Microcomputer Technical Information

<p>μPD789046 Subseries</p> <p>Usage Restrictions</p>	Document No.	SBG-DT-03-0187-E	1/2
	Date issued	July 18, 2003	
	Issued by	Microcomputer Group 2nd Solutions Division Solutions Operations Unit NEC Electronics Corporation	
<p>Related documents</p> <p>μPD789046 Subseries User's manual: U13600EJ2V0UMJ1</p> <p>μPD789046 Data sheet: U13380EJ1V1DS00</p> <p>μPD78F9046 Data sheet: U13546EJ1V0DS00</p>	Notification classification	<input checked="" type="checkbox"/>	Usage restriction
		<input type="checkbox"/>	Upgrade
		<input checked="" type="checkbox"/>	Document modification
		<input type="checkbox"/>	Other notification

***μ*PD789046 Subseries Usage Restrictions**

<Restriction 2>

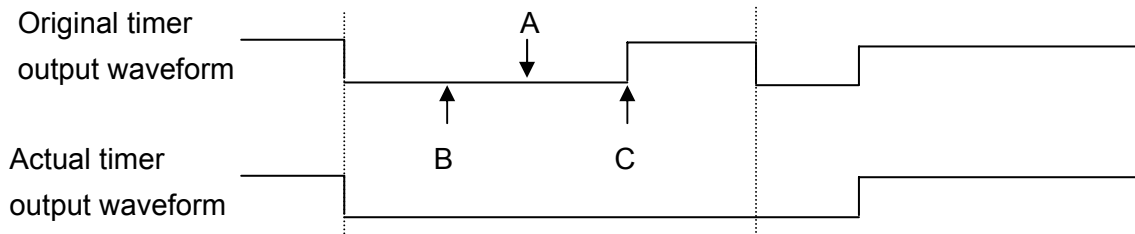
The 8-bit timer does not have a compare register reload function. When the 8-bit timer is used in PWM mode, therefore, the following phenomenon may occur if the value of the compare register (CR80) is overwritten while the timer is operating.

If the value of the compare register is set to "B" while the count value is "A" ($A < C$, $A > B$) where B is the overwritten values of the compare register (CR80) and C is the original value of the compare register (CR80), no pulse is output during this period.

- When modifying the compare register (CR8x)

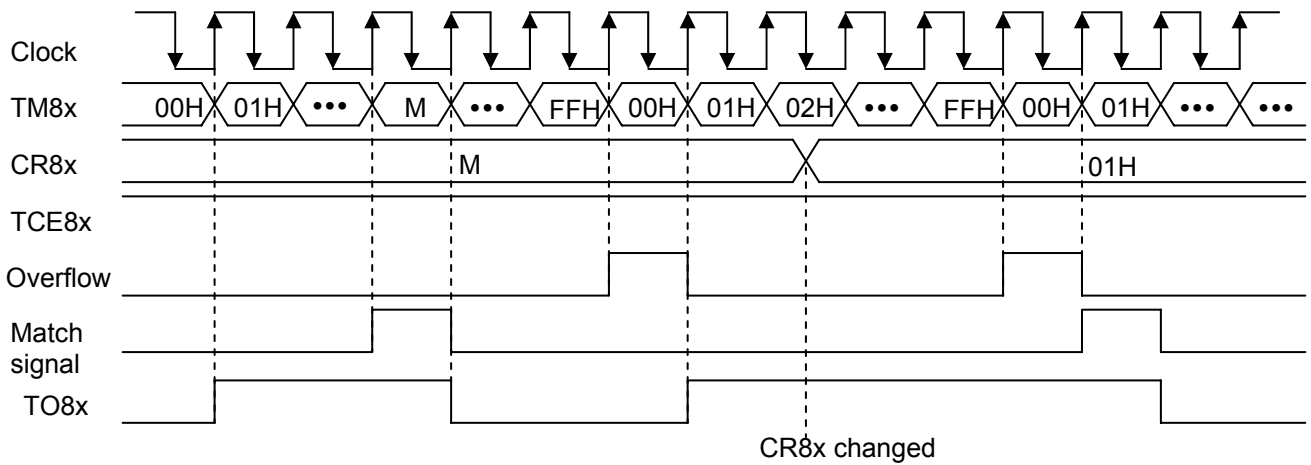
While the timer is operating (during PWM output), if a value is written to the compare register (CR8x), a high level may be output for the next cycle (count pulse \times 256). This phenomenon occurs if a value smaller than the value of TM8x is written to CR8x.

(1) Error upon timer start

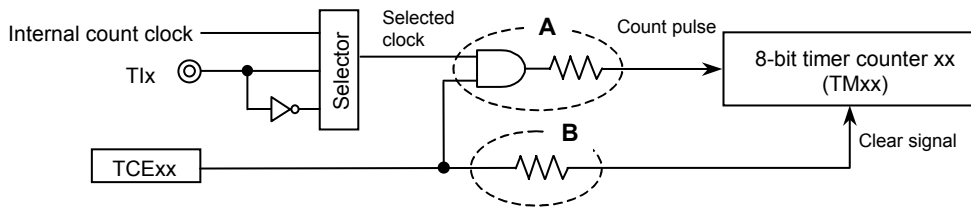
The description in **7.5 Notes on Using 8-Bit Timer/Event Counter (1) Error on starting timer** in the user's manual (U13600EJ2V0UMJ1) has been corrected as follows.

(Incorrect)

An error of up to 1 clock is included in the time between the timer being started and a match signal is being generated.

When the 8-bit timer/event counter is used, an error of up to 1.5 clocks is generated after the timer has been started until a match signal is generated. This is because a rising edge is detected when the timer is started while the selected clock is high, which results in the count value getting incremented.

(Correct)

An error of up to 1.5 clocks is included in the time between the timer being started and a match signal is being generated.

Case when an error of up to 1.5 clocks is generated

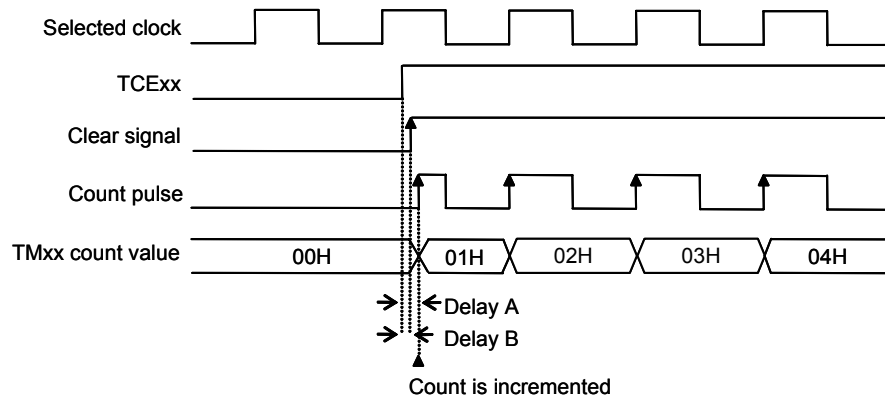
If a count pulse is delayed for the clear signal (“delay A > delay B”) as the result of setting the count operation flag (TCExx) while the selected clock is high, the TMxx count value is incremented. An error of up to 1.5 clocks is generated.

(2) Restriction when an external event is selected for the timer count clock

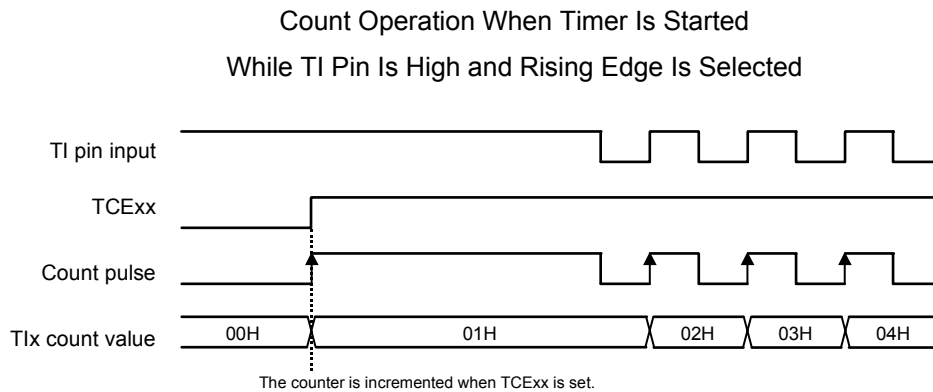
If an external event (TIx pin input) is selected for the timer count clock when the 8-bit timer/event counter is used, the count may be incremented after the count operation flag (TCExx) is set, depending on the status of the valid edge and TI pin.

In the case of “delay A > delay B” as described in (1), the TMxx count value is incremented if any of the following conditions is satisfied.

- The count operation flag (TCExx) is set while the TI pin is high and the rising edge is selected.
- The count operation flag (TCExx) is set while the TI pin is low and the falling edge is selected.

Make allowances for 1-count error in the counter, or implement one of workarounds (1) and (2) below.

- Always start the timer while the TI pin is low if the rising edge is selected.
- Always start the timer while the TI pin is high if the falling edge is selected.

- Save the count value upon timer start in the control register. When reading the count value, subtract this value from the count value saved in the control register and use the result as a true count value.
